ADDENDUM No. 1
Request for Competitive Sealed Proposals (CSP)
19CSP087 Renovations at Pleasant Hill Elementary School

DATE: 1.4.2019
ADDENDUM NO. 1 Renovations at Pleasant Hill ES
Austin Independent School District
Austin, Texas
PROJECT DATE: 11.16.2018
ARCHITECTS: PFLUGER ASSOCIATES, LP
TO: ALL CONTRACT BIDDERS TO WHOM PLANS AND SPECIFICATIONS HAVE BEEN
ISSUED.

RENOVATIONS AT PLEASANT HILL ES AISD - 190028-PLEHL

A2.02 – FLOOR PLAN – AREA A

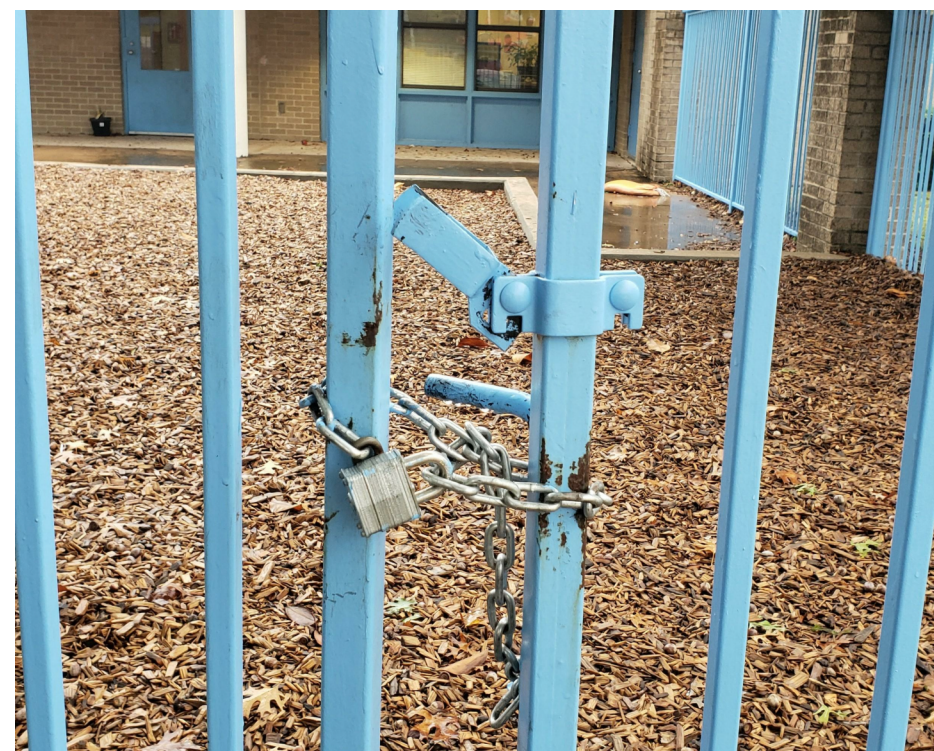
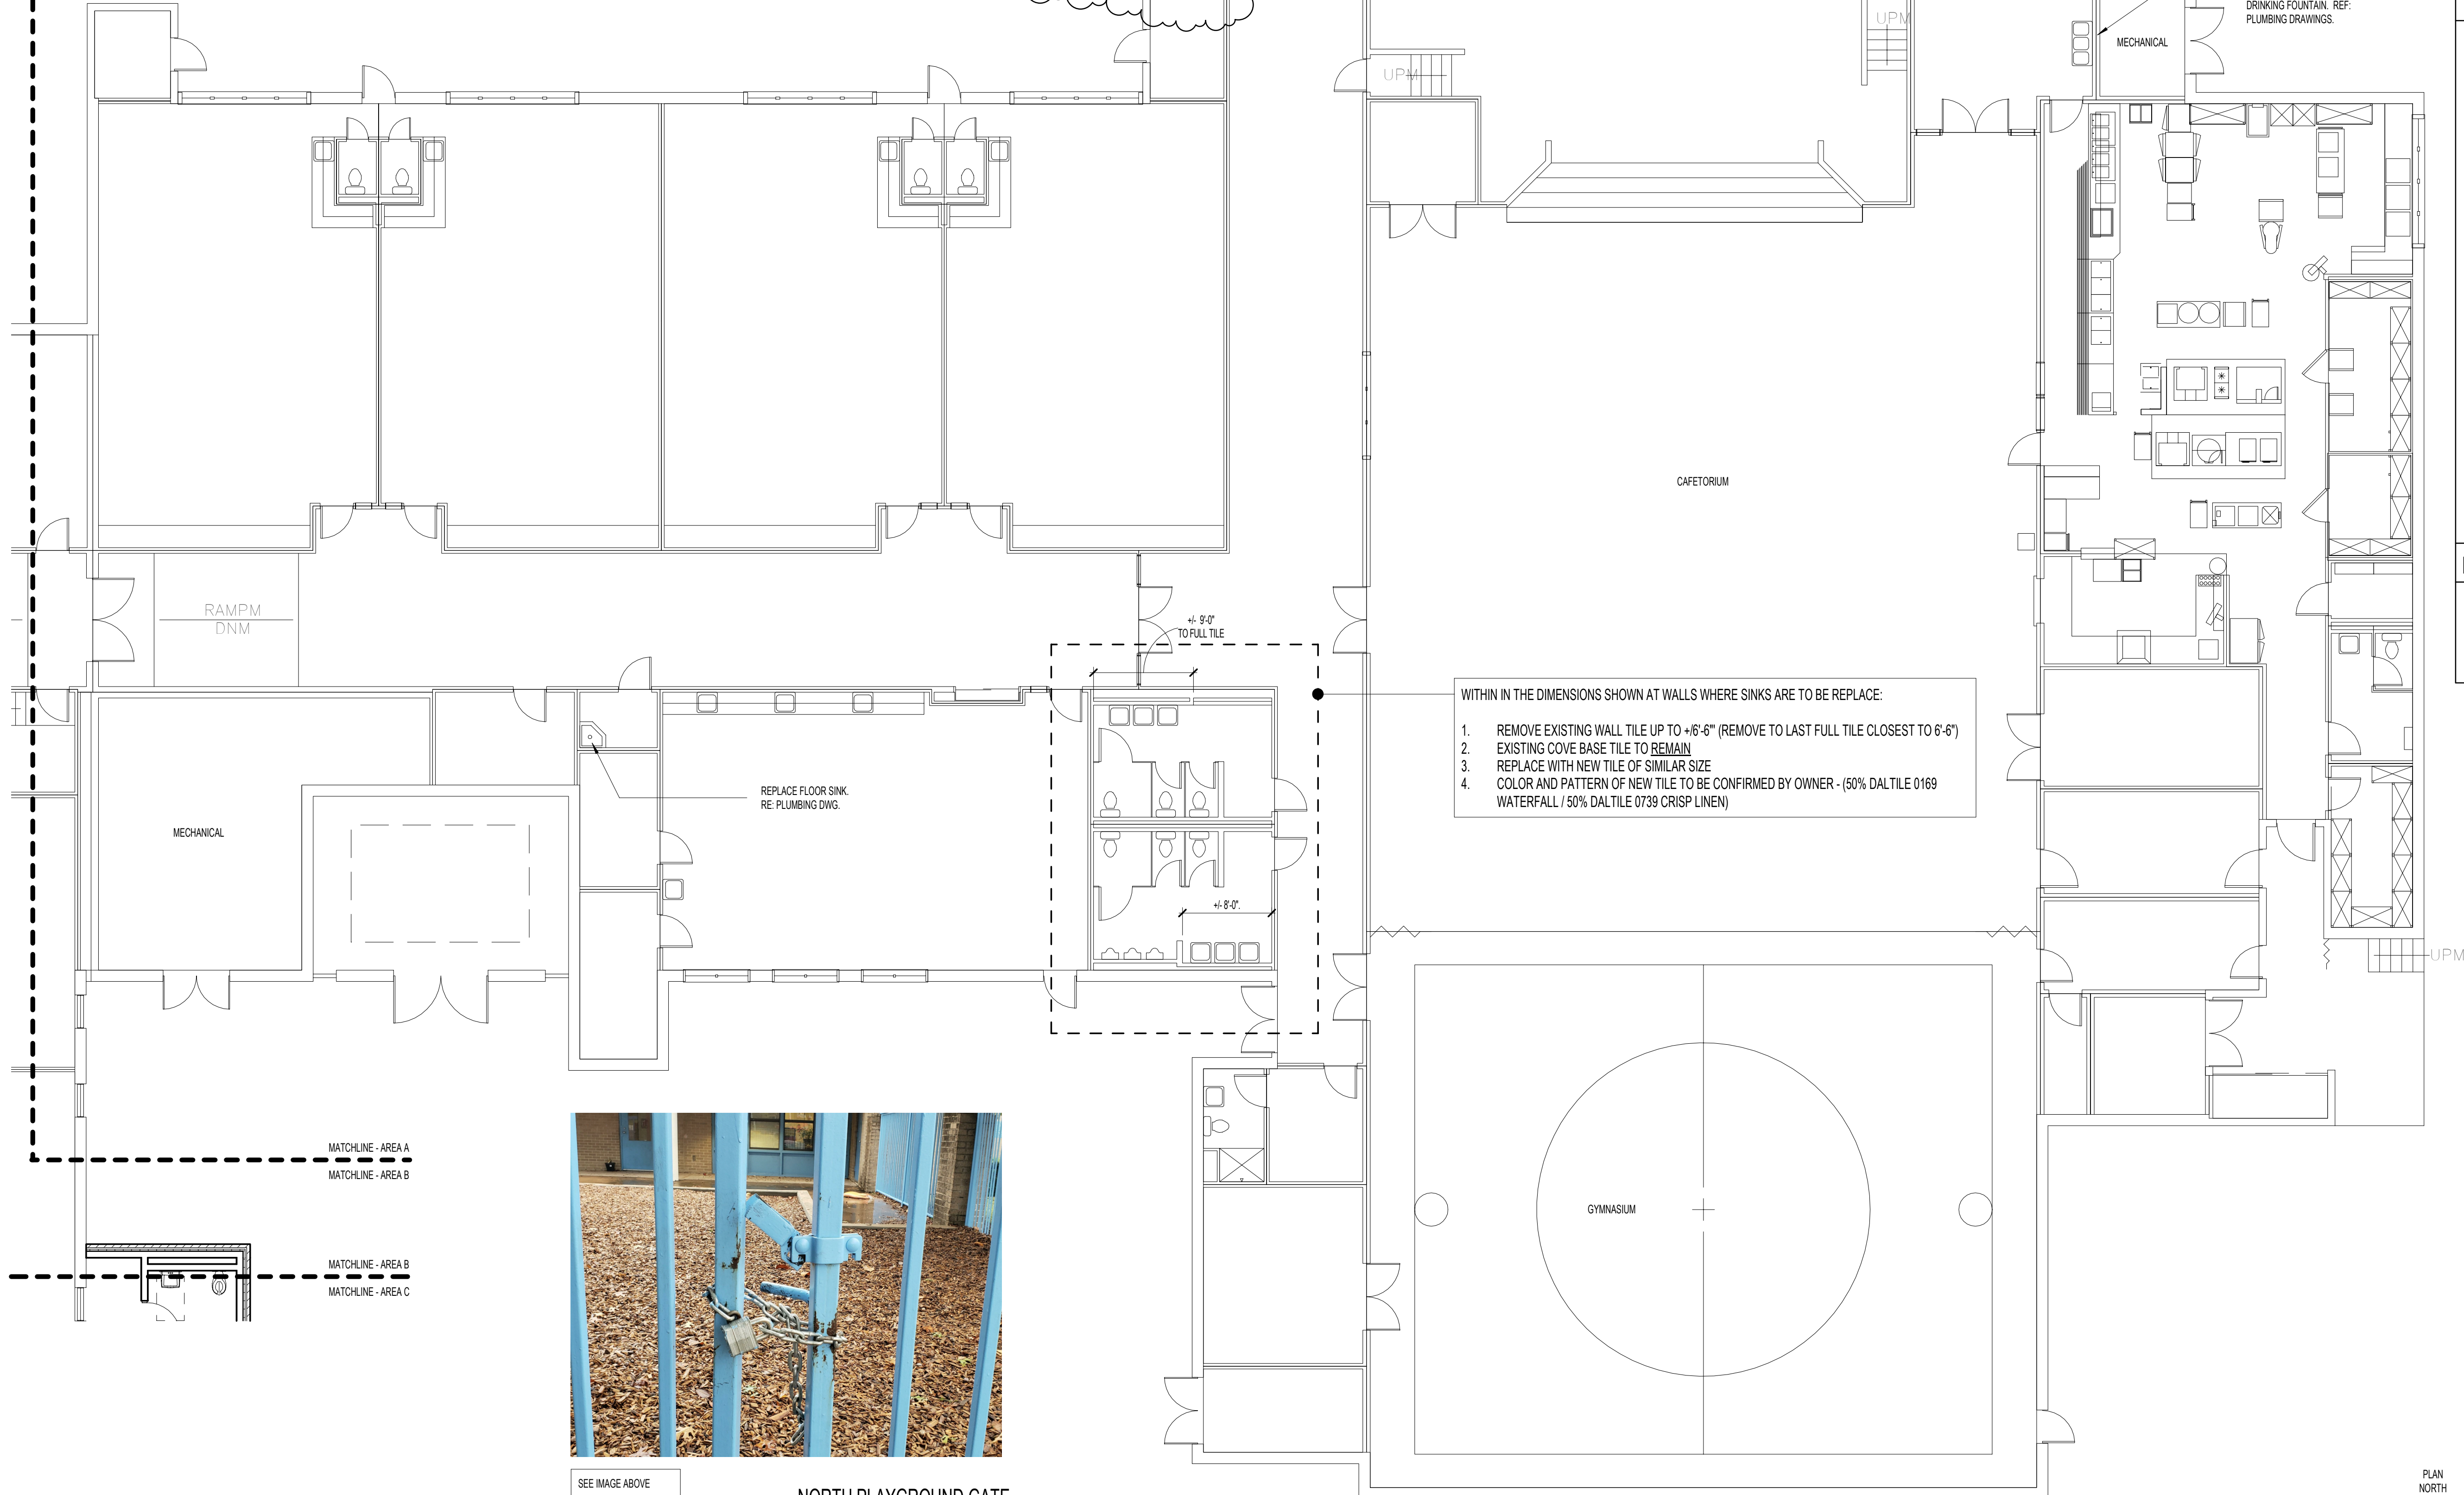
Add additional lockable latch to small playground gate as shown.

NOTE: AT NORTH PLAYGROUND SMALL GATE, PROVIDE AND INSTALL NEW LOCKABLE GATE LATCH. VERIFY W/TYPE WITH ARCHITECT AND OWNER PRIOR TO INSTALLATION.
SEE IMAGE BELOW
